Technical Service Bulletin

SUBJECT:		No:	TSB-19-54-008
UPDATED DIAGNOSTICS FOR ETACS-ECU DTC U0141, B16A0, & B16A7 - SERVICE MANUAL REVISION		DATE:	March 2019
		MODEL:	See below
CIRCULATE TO:	<input type="checkbox"/> GENERAL MANAGER	<input checked="" type="checkbox"/> PARTS MANAGER	<input checked="" type="checkbox"/> TECHNICIAN
<input checked="" type="checkbox"/> SERVICE ADVISOR	<input checked="" type="checkbox"/> SERVICE MANAGER	<input type="checkbox"/> WARRANTY PROCESSOR	<input type="checkbox"/> SALES MANAGER

This TSB updates the Chassis Electrical section of the affected Service Manuals to update diagnostics for ETACS-ECU CAN timeout diagnostics with DTC U0141.

DTC B16A0: Taillight (RH) circuit open <Open circuit in the position light (RH) circuit, rear side marker light (RH) circuit and the taillight (RH) circuit>

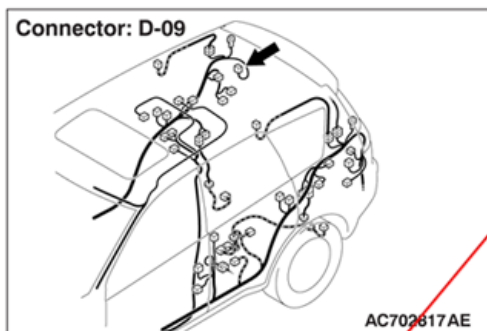
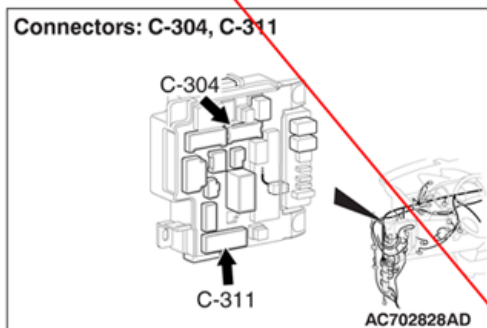
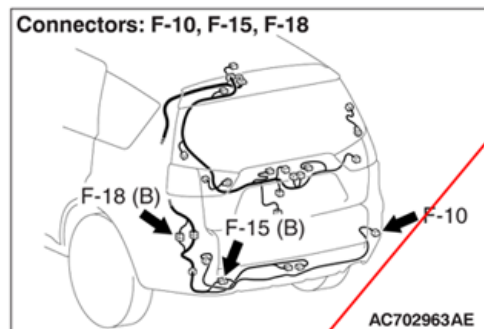
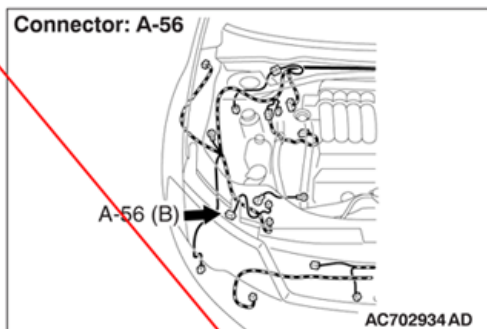
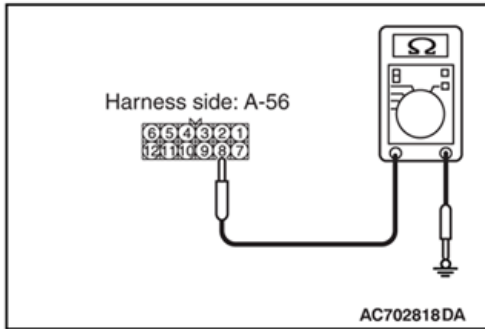
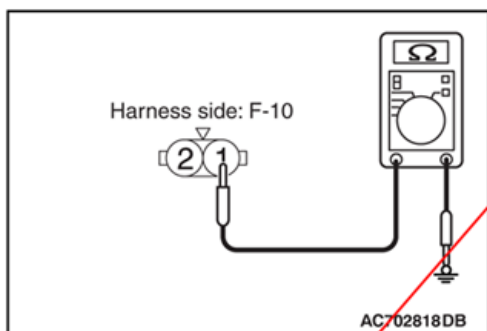
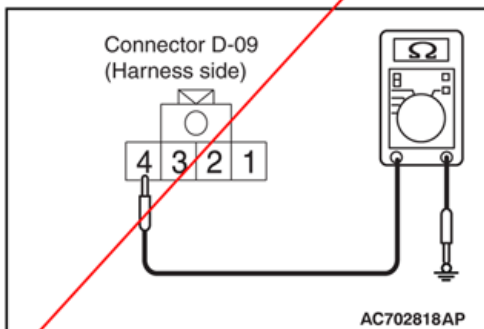
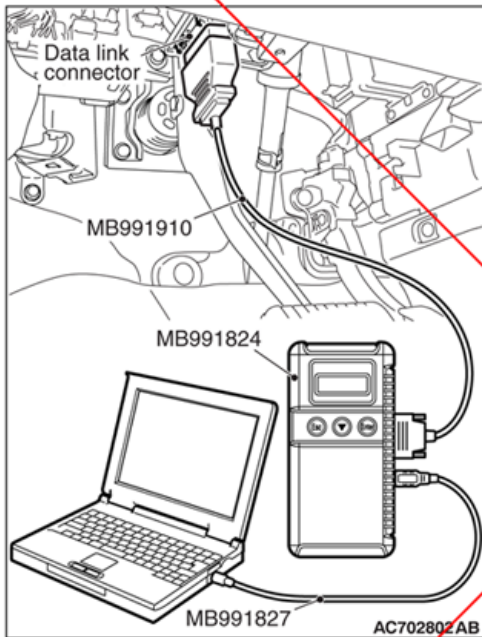
<Incorrect>

<Incorrect>

<Incorrect>

<Incorrect>

DTC B16A0: Taillight (RH) circuit open <Open circuit in the taillight control circuit>
DTC B16A7: Taillight (RH) circuit short <Short circuit in the taillight control circuit>

When an open circuit is detected in the following circuit, the ETACS-ECU sets DTC B16A0. If a short circuit is detected, DTC B16A7 is set.

- Taillight
- Side marker light
- Position light
- Glove box light
- Heated seat (illumination circuit in the heated seat switch) <Up to 2016 model year, and vehicles with heated seat>
